DEPARTMENT OF THE AIR FORCE

HEADQUARTERS 49TH FIGHTER WING (ACC)
HOLLOMAN AIR FORCE BASE, NEW MEXICO

SUBJECT: Request to Administratively Amend the Holloman AFB (HAFB) Resource
Conservation and Recovery Act (RCRA) Permit for Open Detonation Treatment Unit
ID No. NM657124422

Attachment:
Map of HAFB 20,000# ODU

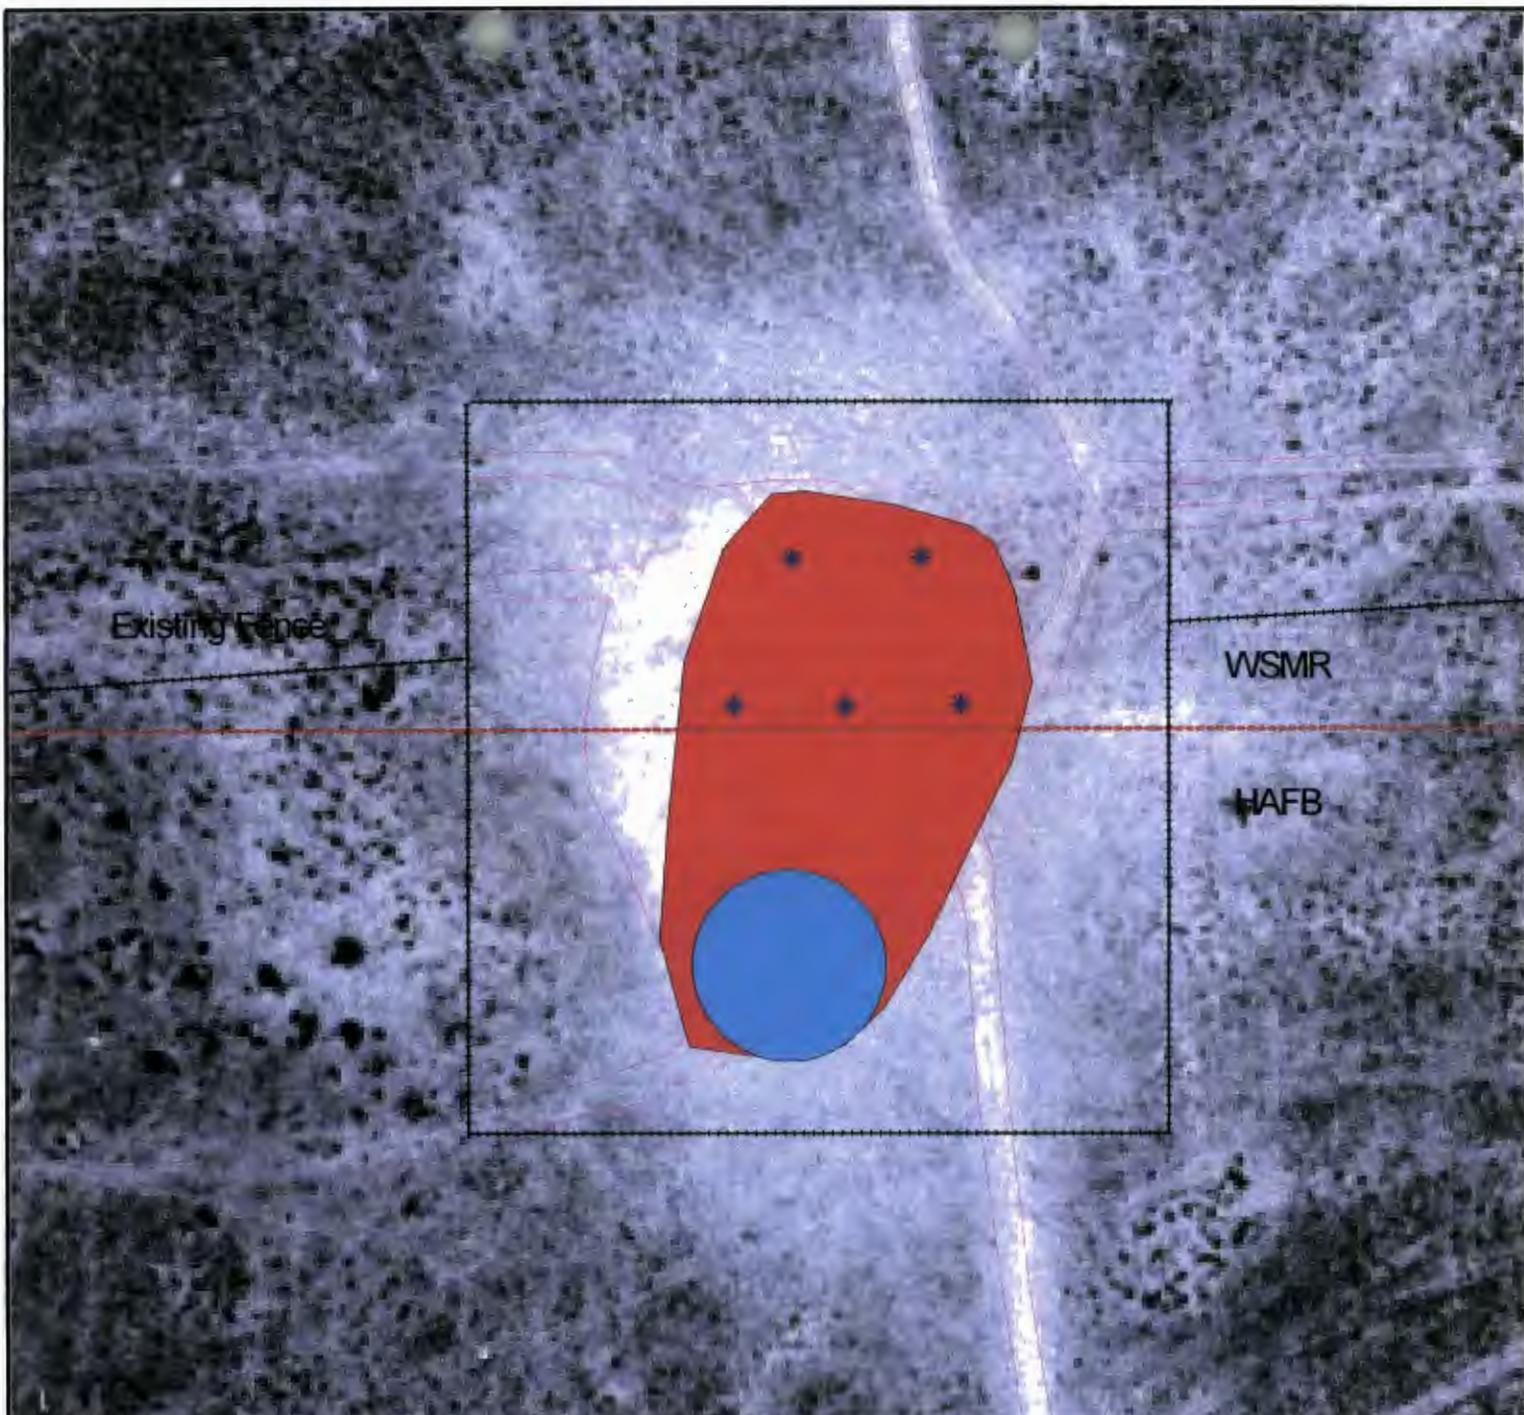
2. Recently, the Explosive Ordnance Disposal (EOD) Manager reviewed one of the several maps from the 20,000 Pound Open Detonation Unit (ODU) RCRA Permit and questioned the accuracy of the map. HAFB personnel then reviewed the permit and found that there are some variations between permit maps. Base personnel utilized recently-acquired Global Positioning System (GPS) equipment to verify the actual location of the ODU. The GPS results show the ODU is slightly north of the area depicted in the originally-submitted permit map questioned by EOD personnel. The actual location of the ODU was initially sited inside the existing fenced area. This fenced area was not initially sited with the aid of GPS technology. We would like to update the permit and insert a more accurate map of the site (similar to the one attached and referenced in Para 3).

3. The ODU permit requires continued grading of the ODU grounds and upkeep of the berm after each detonation event. Meeting these permit requirements, EOD personnel have inadvertently extended the perimeter of the bermed area from approximately 120 feet in diameter to an area approximately 250 feet east to west by 450 feet north to south. This area was extended north from the original location of the ODU because of the additional area available in the northern portion of the fenced zone (attached map). Due to this expanding and the initial siting

ambiguities of the unit, it currently extends on to White Sands Missile Range (WSMR) property by approximately 150 feet. HAFB proposes to follow closure procedures specified in the 20,000 Pound ODU RCRA permit for the northern section of the ODU which extends on to WSMR. Closure of this area would reduce the size of the unit to initially-designed dimensions and configuration. HAFB recently initiated closure sampling of the northern area. Approximate locations of the sampling are shown on the attached map. If the sample results show the area to be at or below background levels determined by the Background Study for the 20,000 pound ODU, then HAFB will initiate clean closure activities. Clean closure consists of covering this area with 6 to 12 inches of local soil material to match surrounding grade and would complete the closure process. The remaining ODU area would be located solely on HAFB property. We would also relocate the northern boundary of the fence to preclude the reoccurrence of gradual creep.
